**2<sup>nd</sup> Further Information**

**Proposed Temporary Warehouse (Excluding Dangerous Goods Godown) with Ancillary Facilities  
for a Period of 3 Years and Associated Filling of Land and Pond in "Agriculture" Zone,  
Various Lots in D.D. 107 and Adjoining Government Land, Fung Kat Heung, Yuen Long**

**(S.16 Planning Application No. A/YL-KTN/1023)**

**Responses-to-Comments**

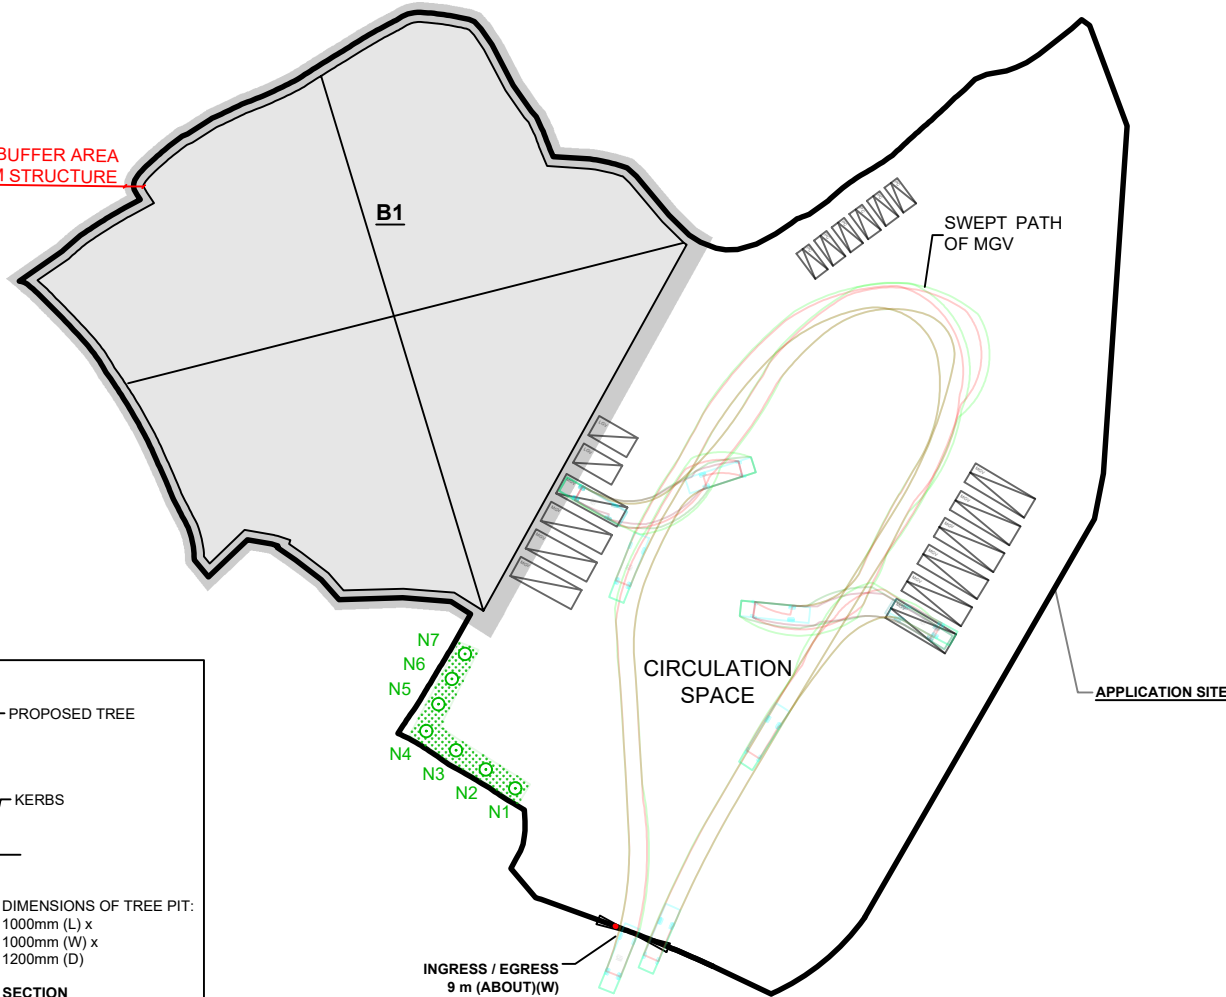
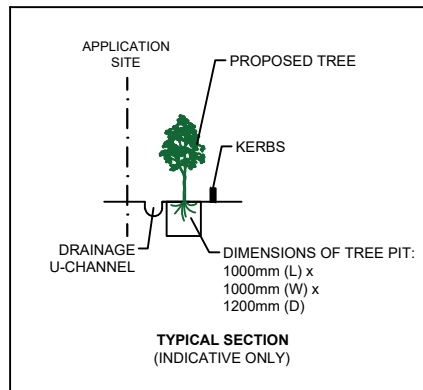
(a)	<p>Having reviewed the Further Information, it is noted that the filling material in the eastern portion of the Site is revised from concrete to soil. 7 nos. of new trees are proposed along the southern site boundary within the Site. Please find our comments from landscape planning perspective:</p> <p><u>Landscape Proposal (ver.001) (Annex IV)</u></p> <p>Considering the species proposed (<i>Ficus microcarpa</i>) is large tree species that can grow up to approx. 25m high with wide crown spread and aggressive roots. The applicant is advised to revise the proposed</p>	A revised landscape proposal has been submitted by the applicant to provide landscape mitigation measure for the proposed development ( <b>Annex III</b> ). A total of 7 Small tree species (i.e. <i>Polyspora Axillaris</i> ), with continuous soil trench, are proposed to be planted along the southwest portion of the Site as a landscape buffer to the surrounding areas. All these new trees within the Site will be maintained by the applicant during the planning approval period.

species to small tree species to suit the site context.	
(b)	The applicant is advised to revise the individual tree pits proposed to a continuous soil trench to facilitate growing of tree as far as possible. Relevant description and dimension should be reviewed.	
<b>5. Comments of the Director of Agriculture, Fisheries and Conservation (DAFC) (Contact Person: Ms. WONG Cheuk-ling; Tel.: 2150 6933)</b>		
(a)	The applicant has not provided information on the type of soil to be filled.	Loam would be used for filling of land and pond for the proposed development.

NO. OF NEW TREES WILL BE PLANTED	: 7	(N1 TO N7)
SPECIES OF NEW TREES	: POLYSPORA AXILLARIS	
HEIGHT OF NEW TREES	: NO LESS THAN 2.75 m	
SPACING OF NEW TREES	: NOT LESS THAN 4 m	
DIMENSION OF SOIL TRENCH	: 1.2 m (W) X 1.2 m (D)

- 1) THE APPLICANT WILL MAINTAIN TREES IN GOOD CONDITION DURING THE PLANNING APPROVAL PERIOD.
- 2) THE APPLICANT WILL REPLACE TREES WHICH ARE DYING OR DEAD DURING THE PLANNING APPROVAL PERIOD.
- 3) THE APPLICANT WILL PROVIDE ADEQUATE IRRIGATION FOR TREES.
